Addendum to MC68450 Direct Memory Access Controller

The following information applies to ADI1216, MC68450 Direct Memory Access Controller (DMAC) Advance Information Data Sheet for the **A84G Mask only**:

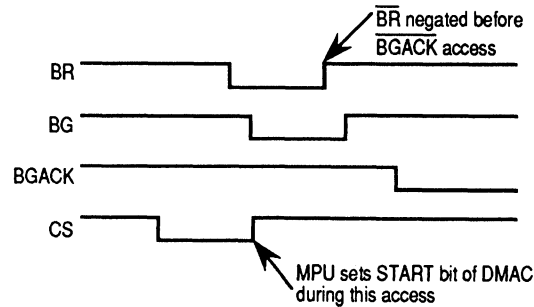
4. When the MPU sets the START bit of the DMAC and a different channel is already active in the limited rate auto-request mode (LRAR), then the following bus arbitration timing may occur:

This timing diagram shows that the $\overline{BR}$ is negated too early and may cause a bus contention between the MPU and DMAC. The problem occurs in the following conditions:

- a. Two or more channel are in operation.
- b. One of the channels is in the LRAR.
- c. The priority level of the LRAR channel is higher than or equal to the other channels.
- d. The LRAR channel is initiated before the other channels.

Suggested countermeasures are as follows:

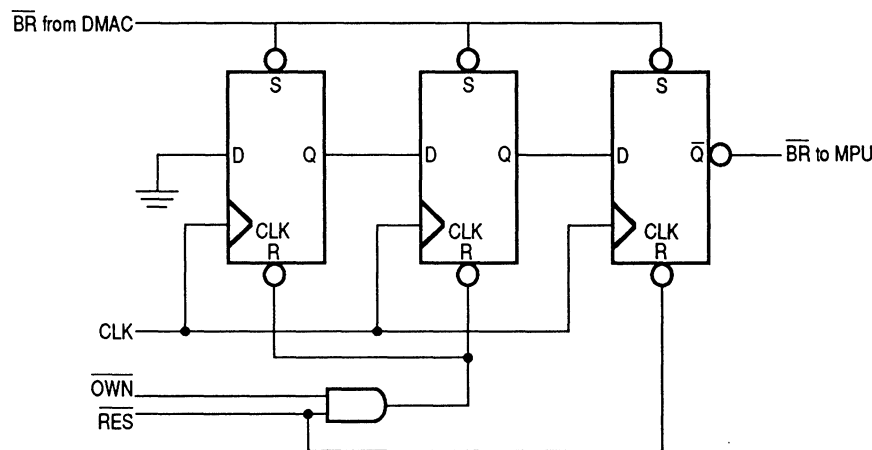
- a. Set the priority of the LRAR channel to the lowest level. If two or more channels are set to LRAR, a lower priority channel should be initiated first.
- b. External latches should be provided for as shown in the following diagram:
